# Structural

## Part 1 - Proposed Code Modifications

### Glitch Modifications

Total Mods for **Structural** in **Pending Review**: 85

**FIGURE R606.13.9A**  
**CONTINUITY OF REINFORCEMENT**  
**ONE STORY MASONRY WALL**

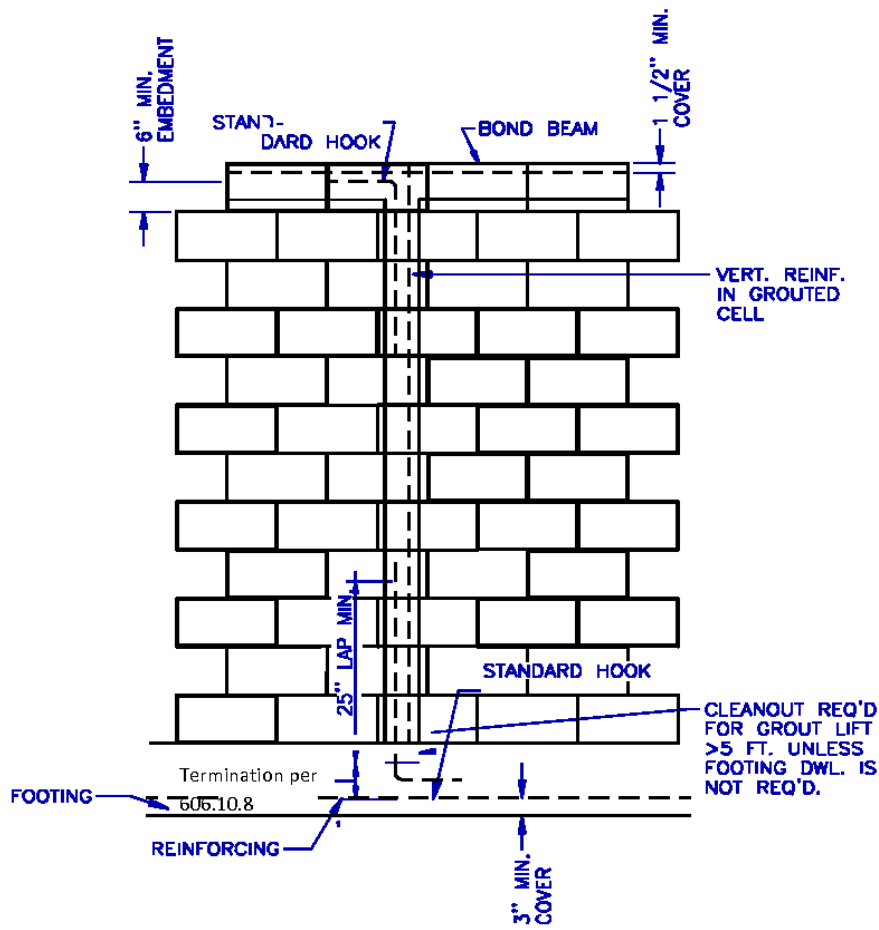
**R606.13.9 Continuity multi-story construction.** Vertical wall reinforcement in multi-story construction shall extend through bond beams and shall be continuous with the vertical wall reinforcement of the wall above or be offset in accordance with Section R606.13.1 and Figure R606.13.9B.

**R606.13.9.1 Offset reinforcement.** Vertical reinforcement shall be permitted to be offset between floor levels. Reinforcement for the lower story shall be anchored into the upper floor level bond beam and reinforcement for the upper story shall be anchored into the bond beams above and below in accordance with Section R606.13.8 and Figures R606.13.9A and R606.13.9B.

**TABLE R609.4B WOOD GABLE STUD CONNECTOR LOADS**

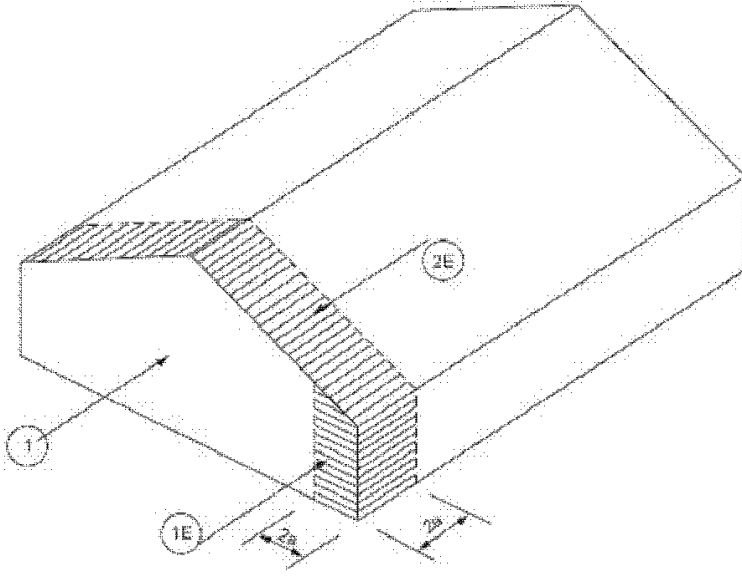
Add the following figure to the bottom of Table R609.4B:

**FIGURE R613.5(3) TRUSSED ROOF TO TOP PLATE CONNECTION**

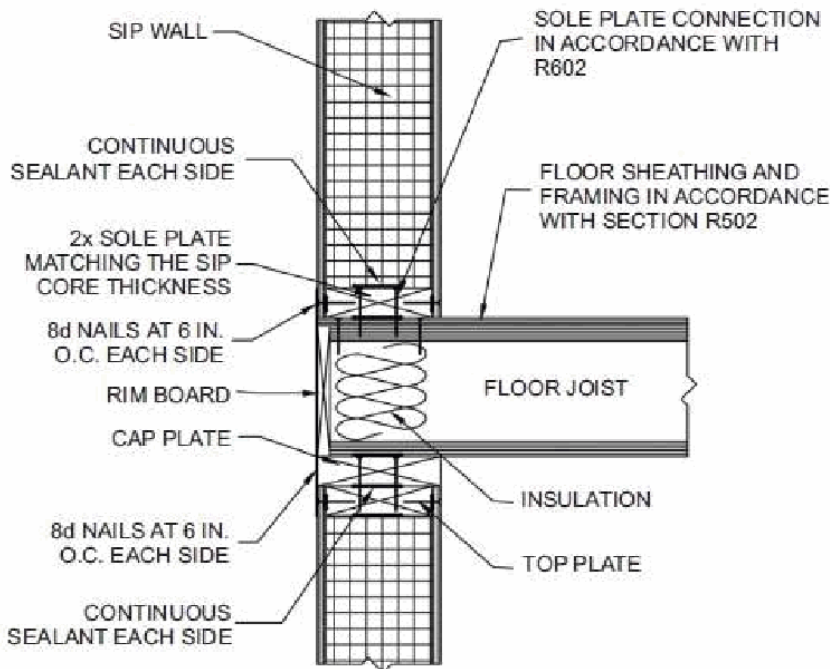
Replace Figures R613.5(3), R613.5(4), R613.5(5), and R613.5.1 with the figures in the attached file.

**FIGURE R614.3(1) DIRECT TRUSS TO CONCRETE, MASONRY OR ICF WALL CONNECTION FOR GYPSUM BOARD CEILING DIAPHRAGM**

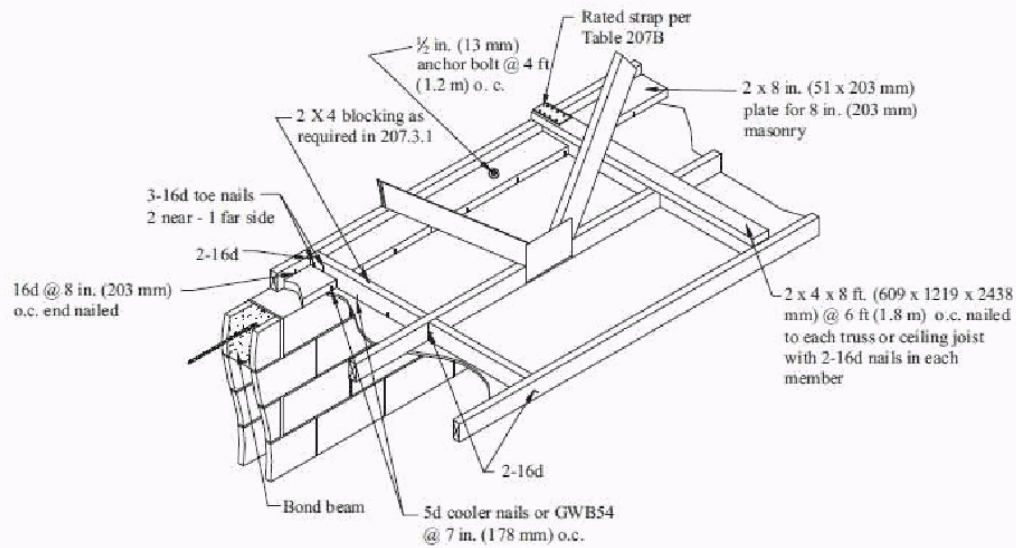
Add Figures R614.3(1) and R614.3(2) as shown in the attached file.
